PLAN COMMISSION

March 10, 2020

Proposal: Master Landscape Plan Review – Creekside Crossing Marketplace

Proposal: Landscape Plan Review – Stand Rock Hospitality

DESCRIPTION
PERIMETER PLANTING REVISIONS

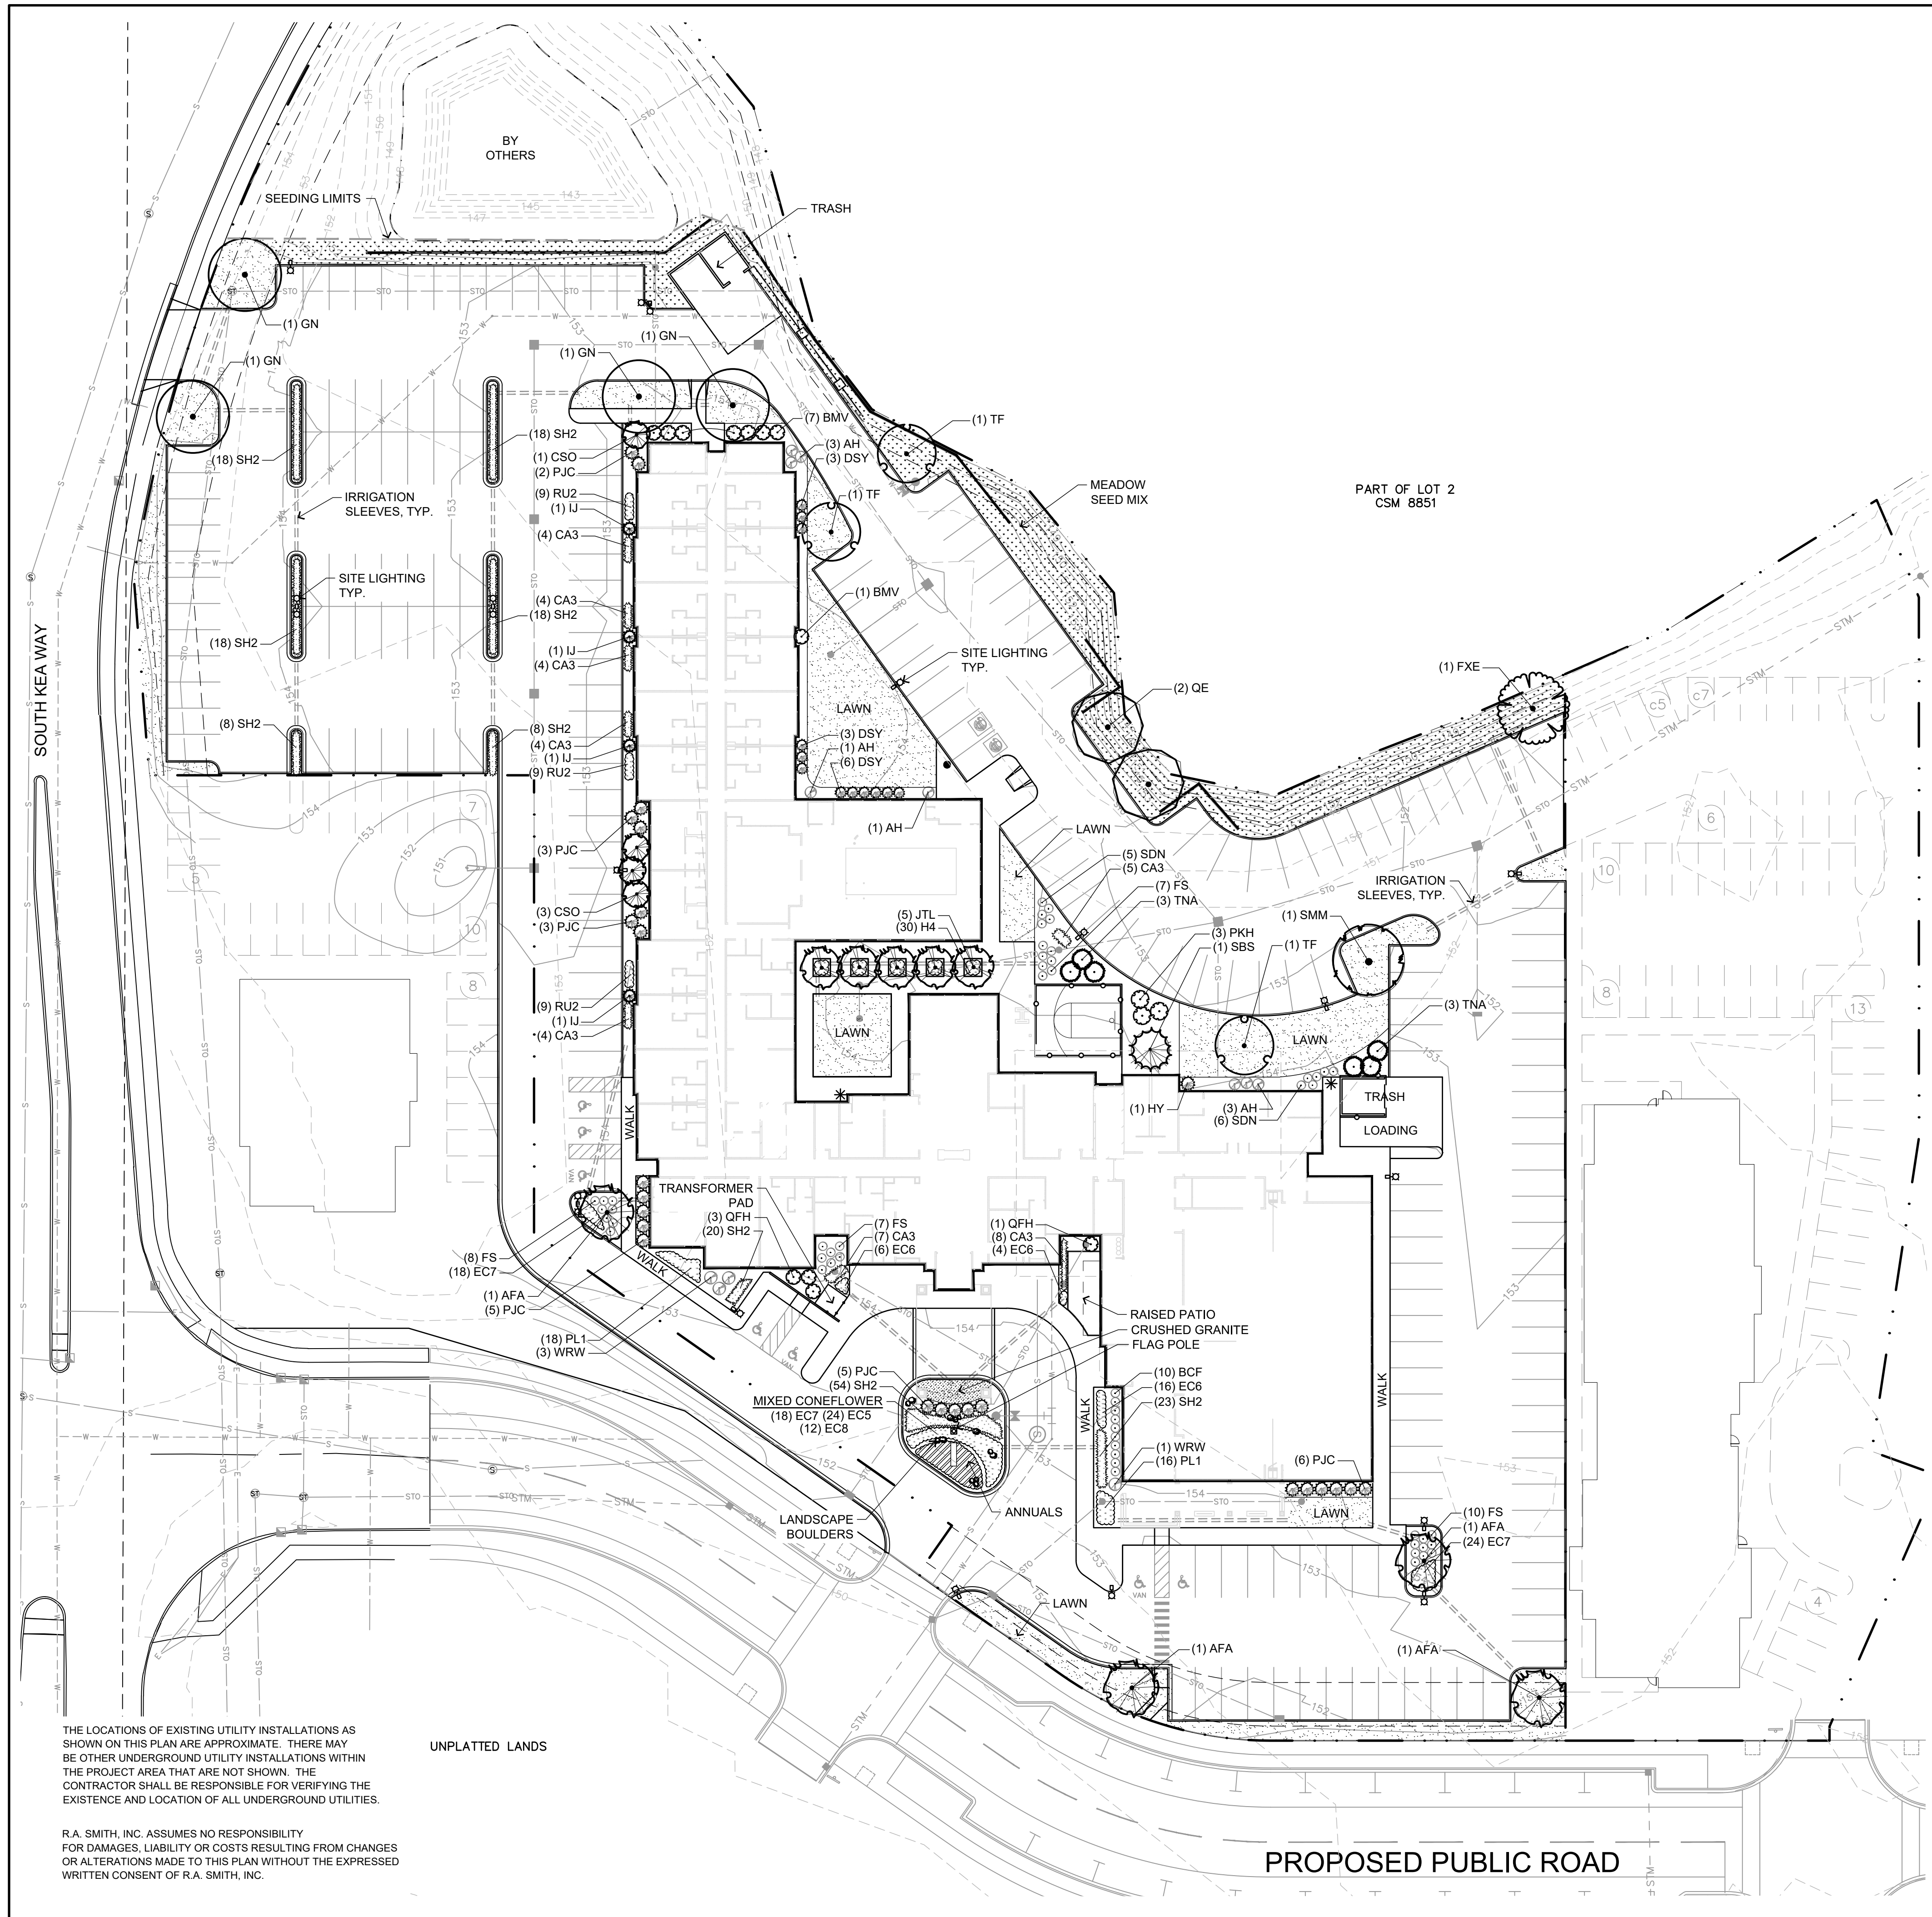
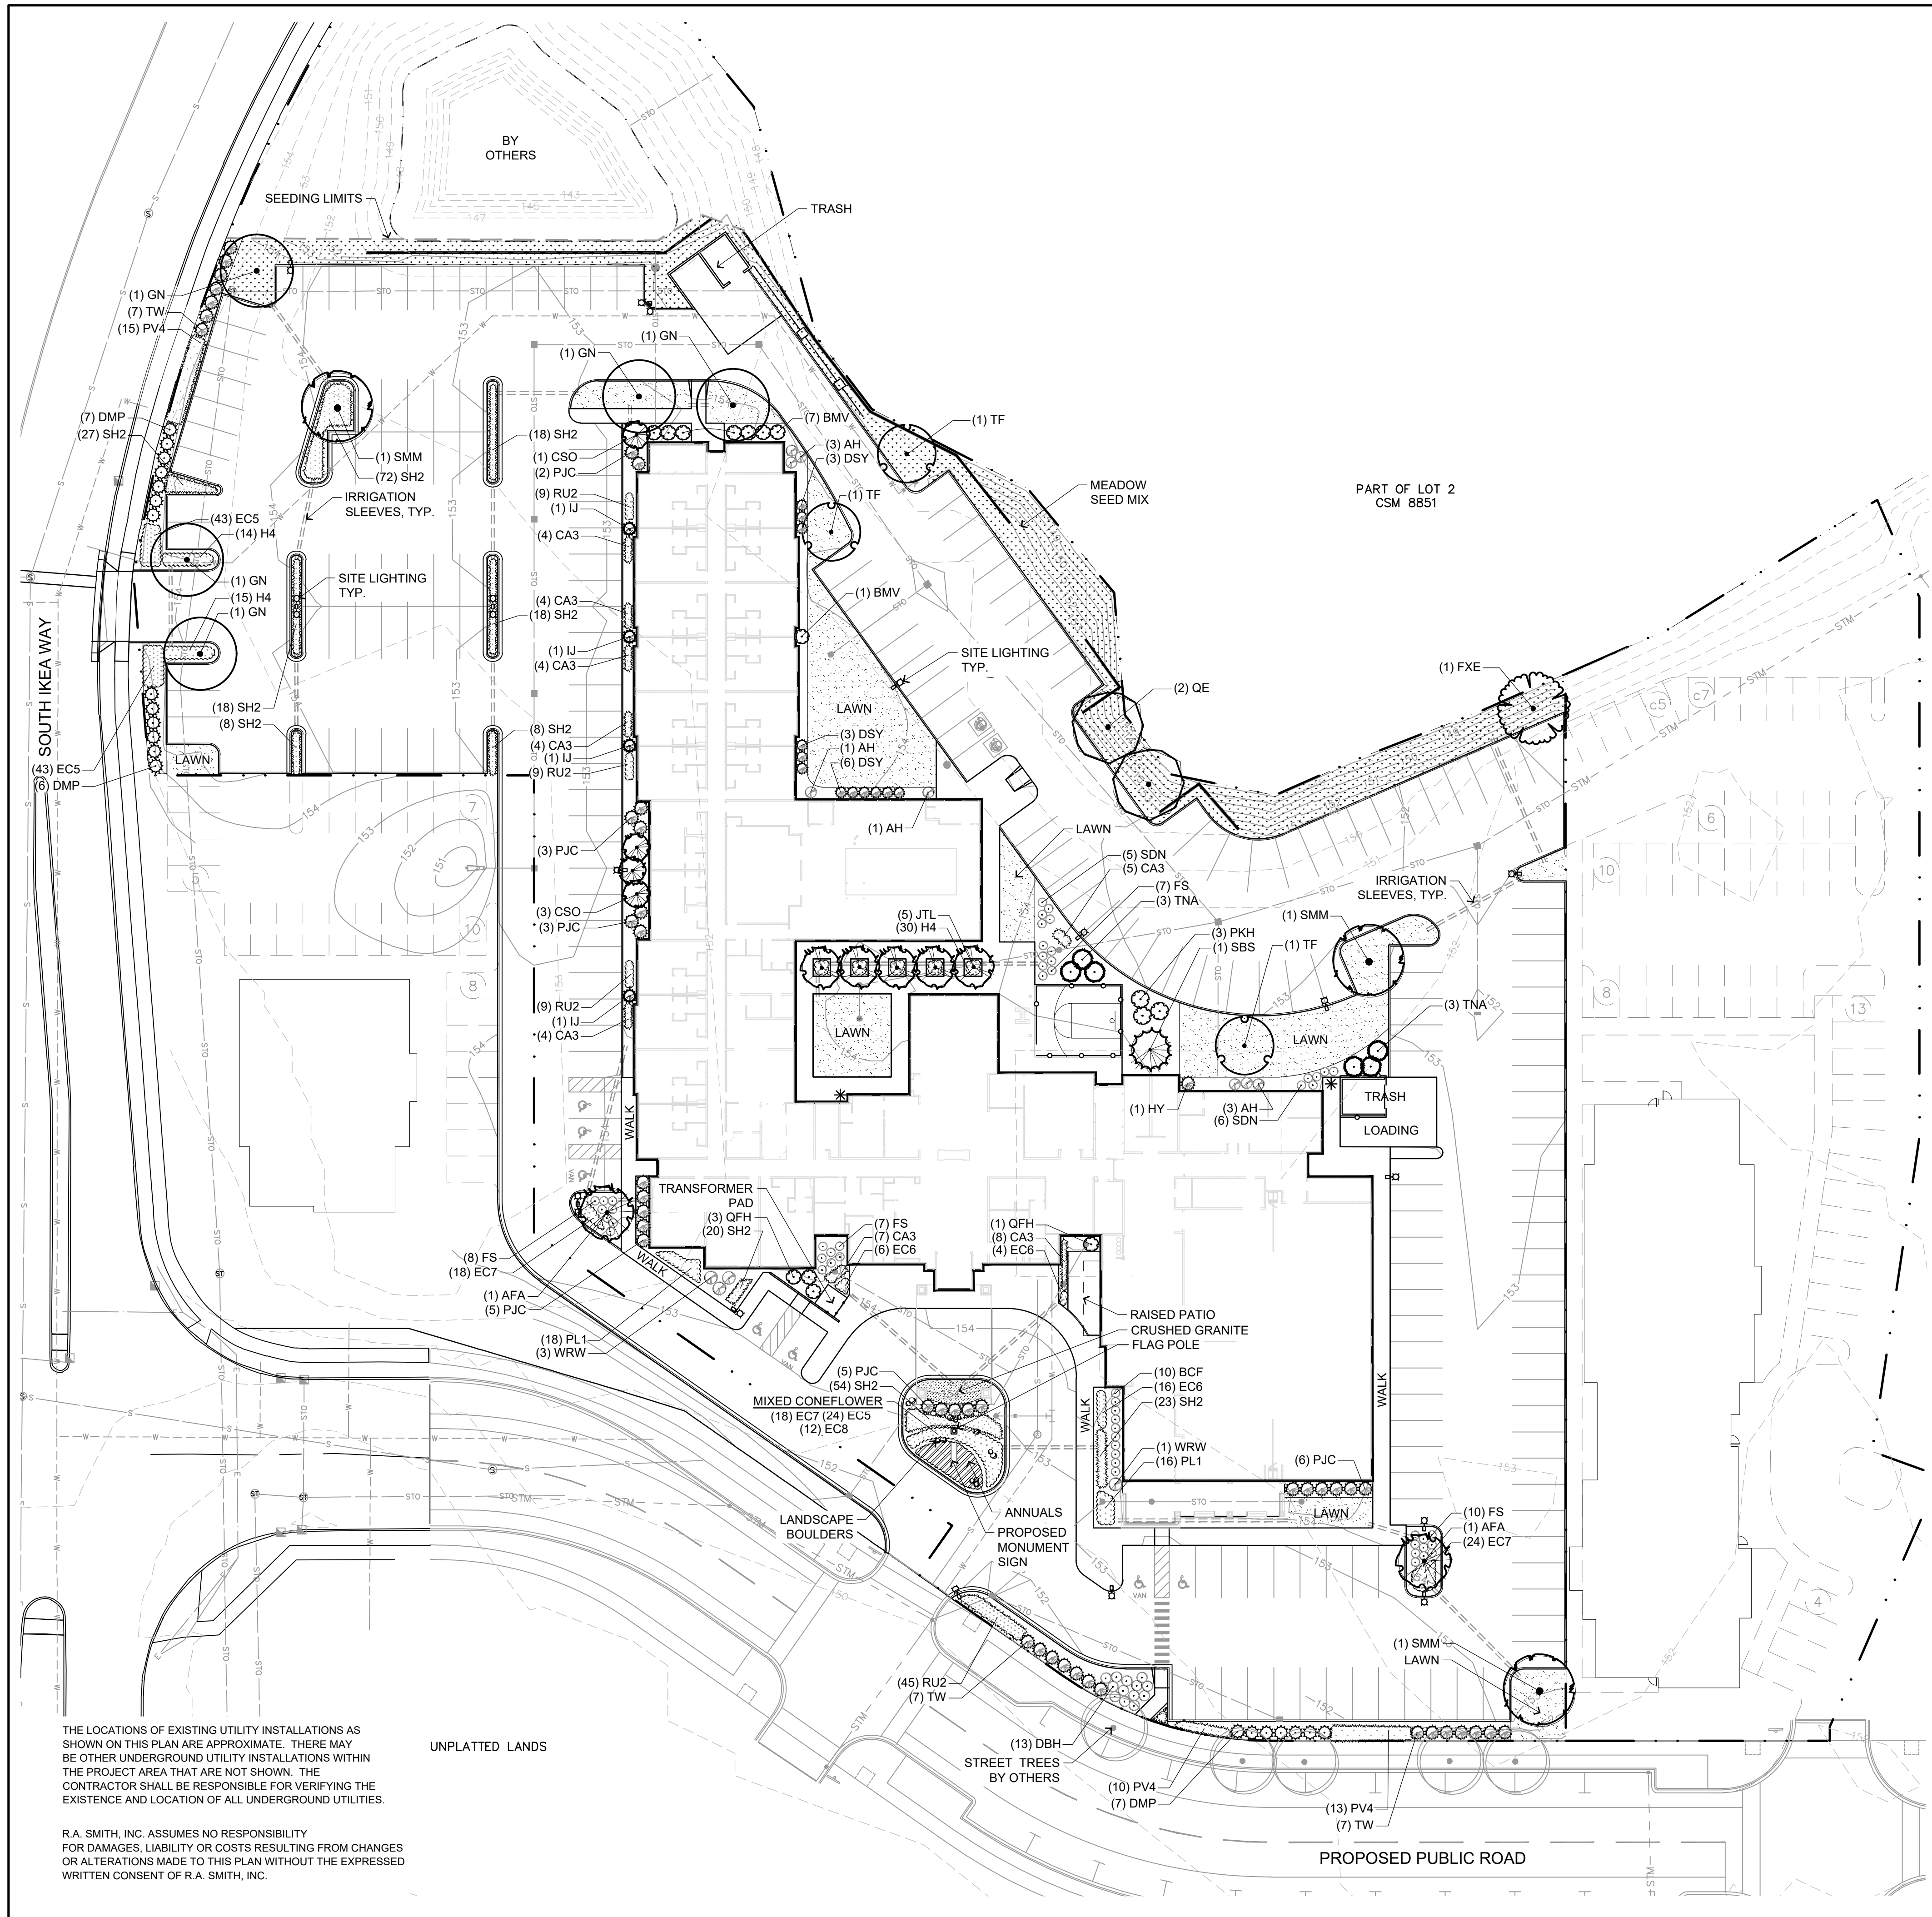
review of the proposal, and within the staff report, it was stated that parking areas per the approved PUD are required to be a minimum of 5 feet from all public rights-of-way, and front and rear lot lines. The plans showed two (2) parking stalls encroaching into the public right-of-way/front setback requirement. Modifications to any parking setback may be granted by a $\frac{3}{4}$ majority approval of the Plan Commissioners present at the meeting, “but only if deemed consistent with an approved Master Landscaping Plan.” Likewise, the minimum 5-foot-wide perimeter landscaping requirement may be modified by a $\frac{3}{4}$ majority of Plan Commissioners present at a meeting, “but only if deemed consistent with an approved Master Landscaping Plan.” Said Master Landscaping Plan was presented for Plan Commission review in the previous agenda item.

Updates to the plans incorporate the revision to the secondary access on Ikea Way, repositioned landscape islands, landscaping along the public rights-of-way, and for screening those parking stalls adjacent to public rights-of-way. However, where plants are being used for screening purposes, the heights of plants must be installed and maintained at a minimum of 3 feet. This must also appear on the landscape plans in addition to the minor revisions required for compliance with the Creekside Crossing Marketplace Landscape Design Guidelines and Master Landscape Plan as identified in the staff comments attached to this report.

1. That all relevant Code requirements remain in effect.
2. That all conditions of approval from the February 25, 2020 Plan Commission review are in effect.
3. That a revised landscape plan incorporating staff comments is submitted in digital format for review by the Department of Community Development prior to the submission of building permit applications.
